MECKLENBURG COUNTY
HEALTH DEPARTMENT

APPLICATION FOR APPROVAL TO USE AN EXISTING ON-SITE WASTEWATER TREATMENT & DISPOSAL SYSTEM / WATER SUPPLY WELL

JOB LOCATION INFORMATION
TAX PARCEL #: 139-072-15
STREET ADDRESS: 9719 Bartlett Rd
CITY: Chas.
STATE: NC ZIP: 28227

SOIL/SITE EVALUATION for ON-SITE WASTEWATER SYSTEM

PROPOSED PLOT PLAN

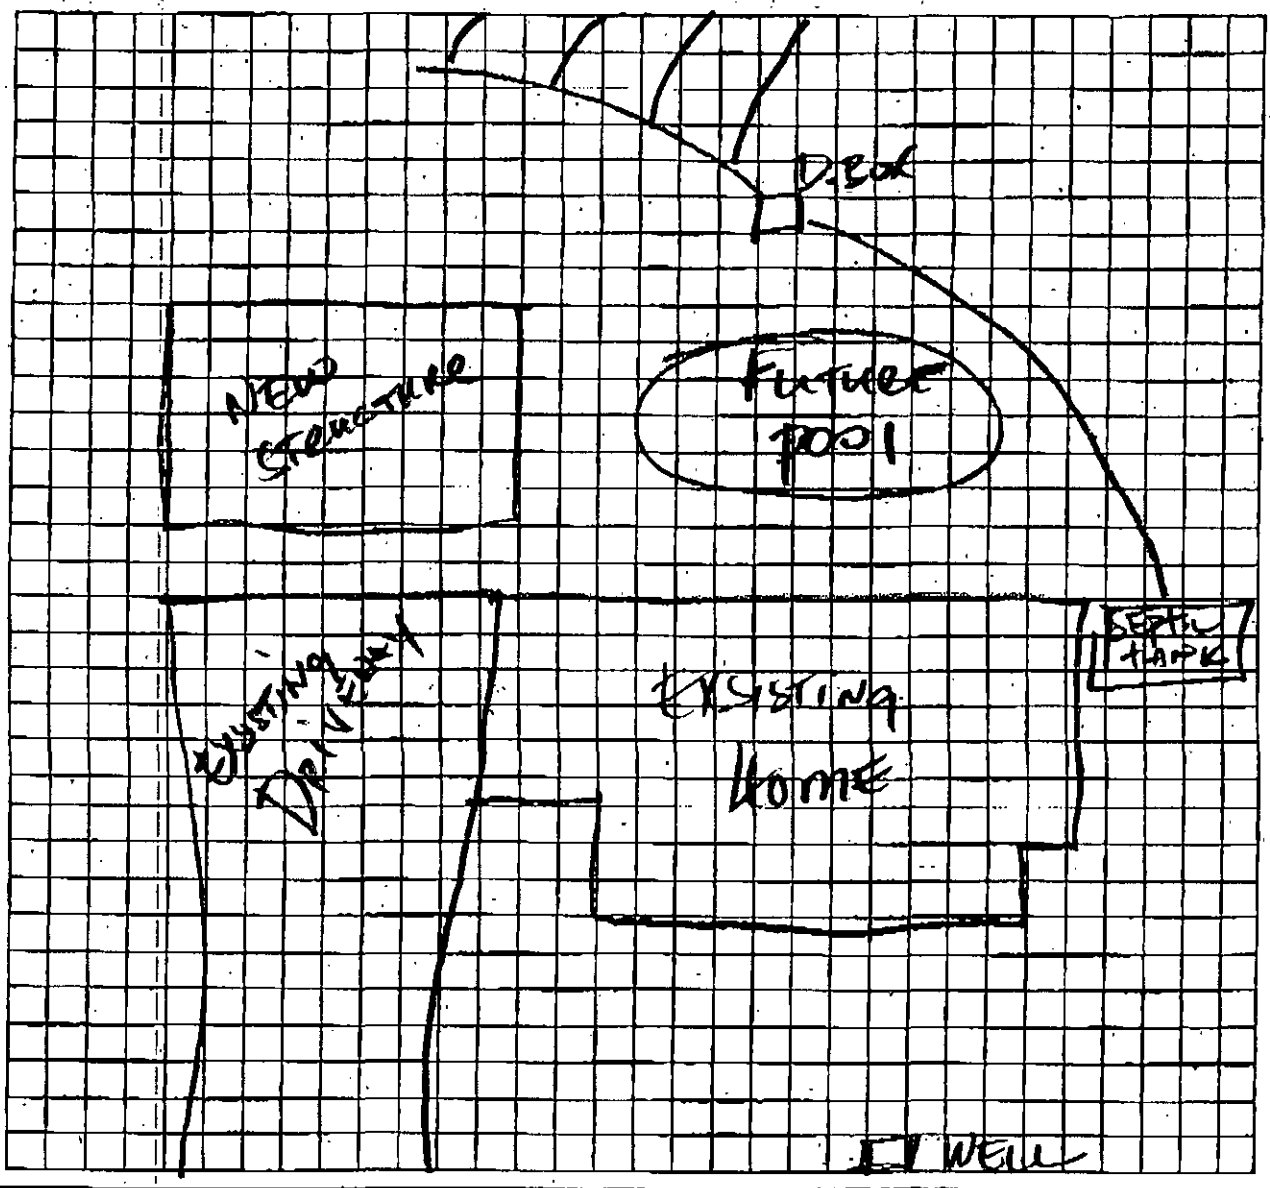
Garage Meets Required setbacks off septic

Sketch of Soil Evaluation Locations

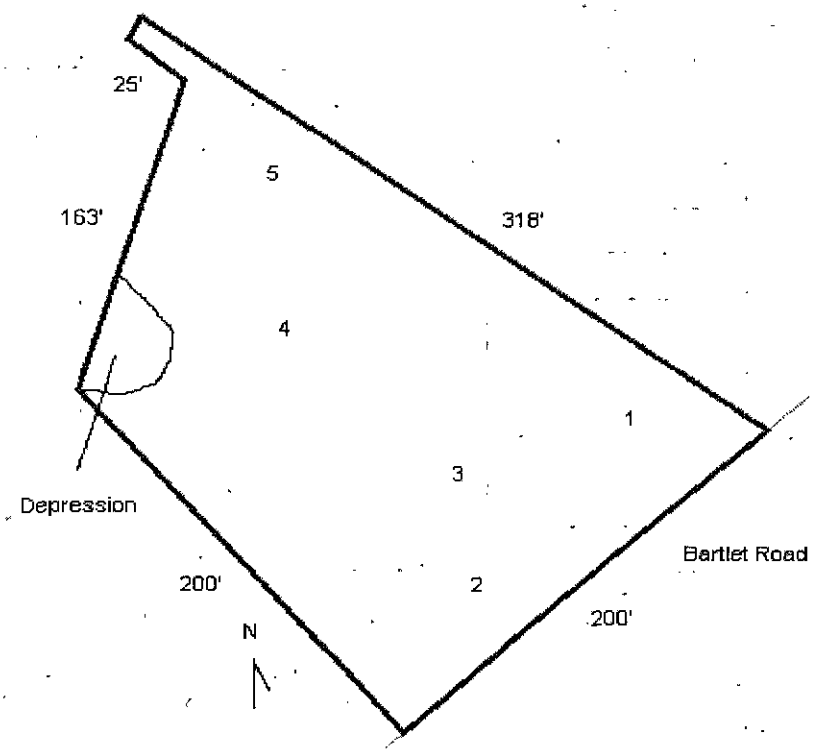
Does not appear to be 100% repair

SKETCH OF SYSTEM LAYOUT
(Proposed Layout)

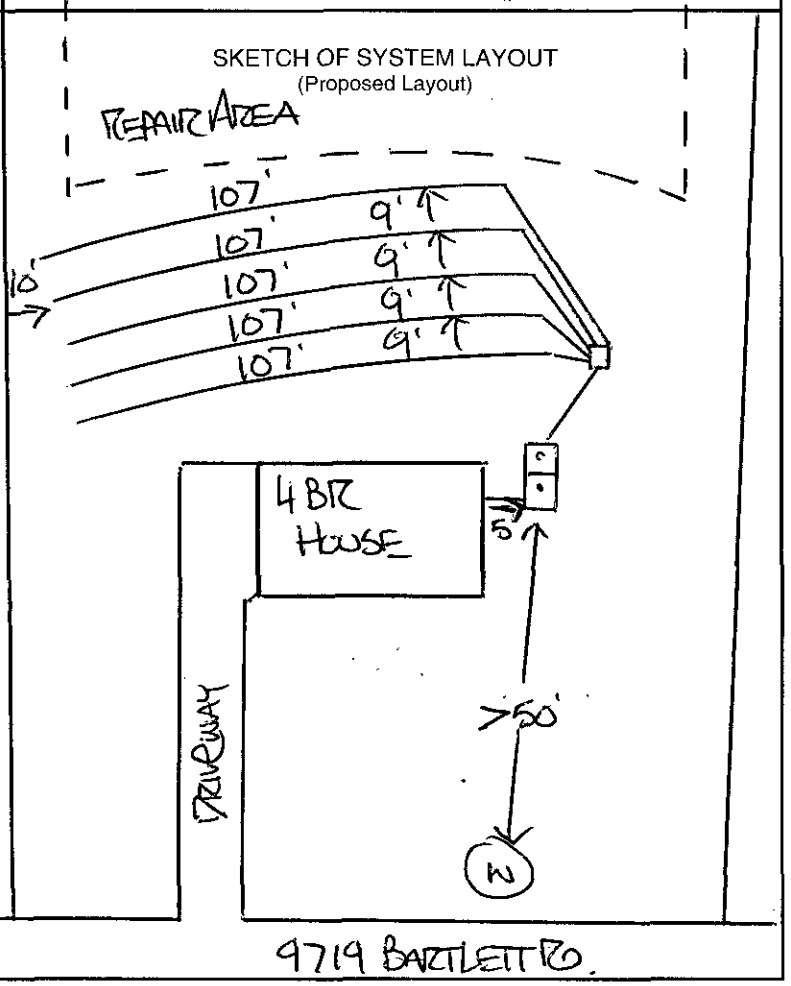
Comments: System Classification & Type: TYPE II CONVENTIONAL, INSTALL 5 LINES @ 107', ON CONTOUR ON 9' CENTERS., 1500 ST, D-Box. KEEP >50' FROM WELL, 75' FROM HOUSE >10' FROM PROPERTY LINE.

PROPOSED PLOT PLAN

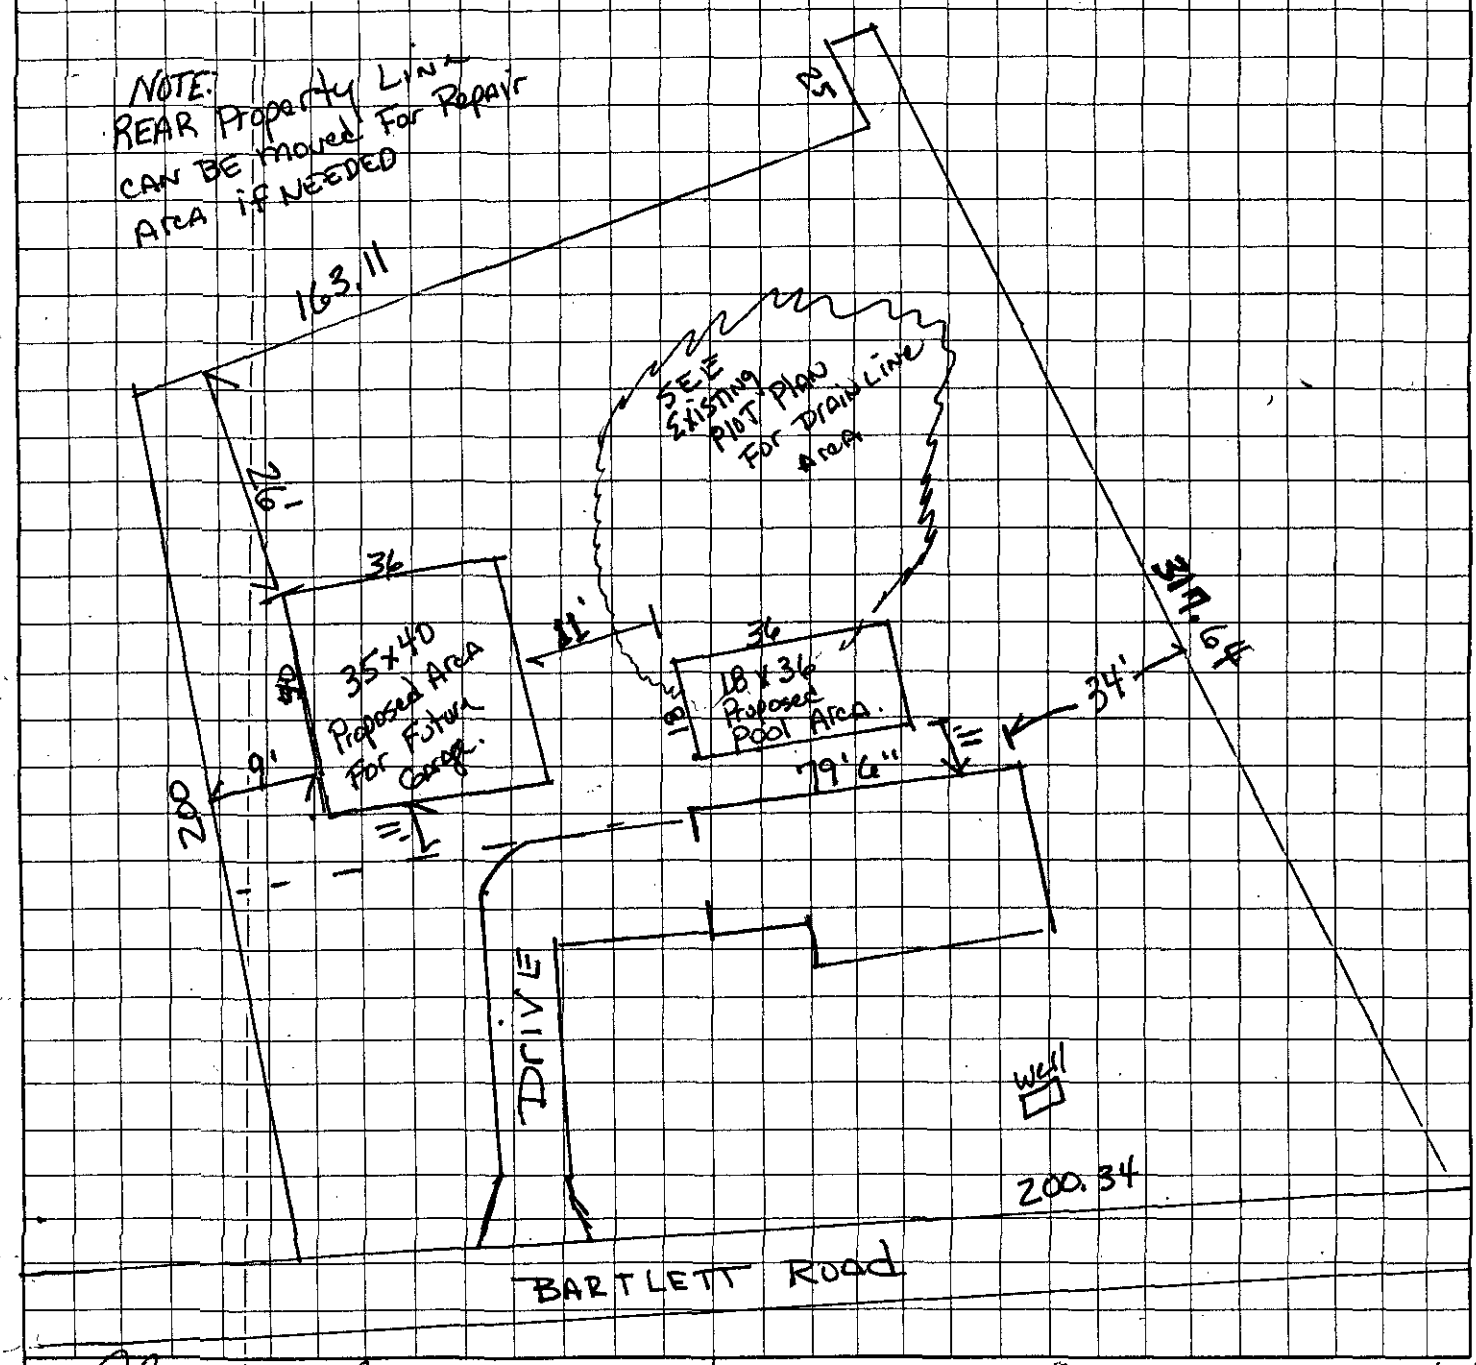
Chg in Plot Plan
#100 CHKH 664
5/18/06

SKETCH OF SYSTEM INSTALLATION
(As-Built Drawing)

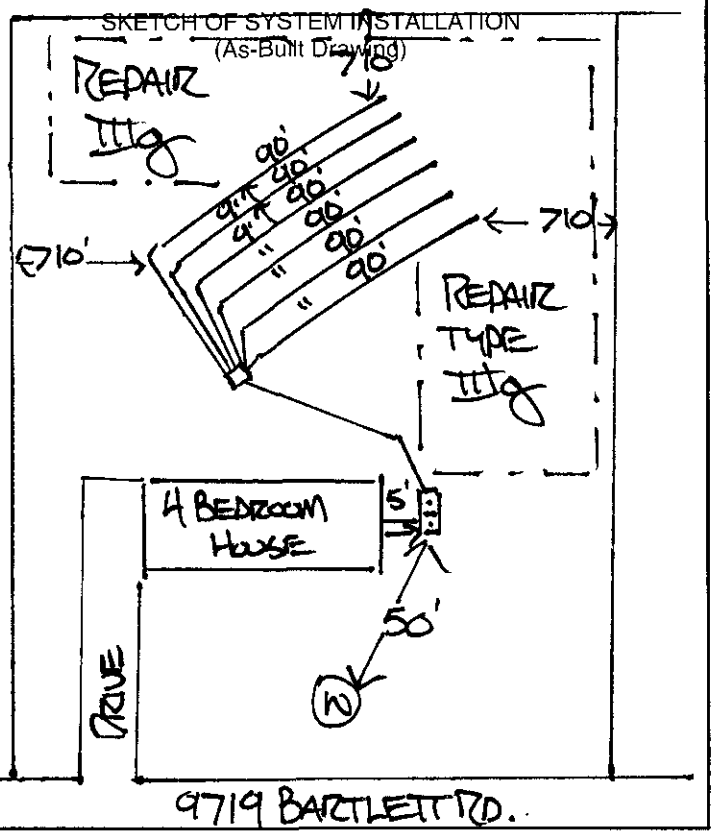
Comments: System Classification & Type: TYPE II CONVENTIONAL; SIX LINES INSTALLED @ 90' EACH. 1600 GAL ST, D-BOX. 750' FROM WELL
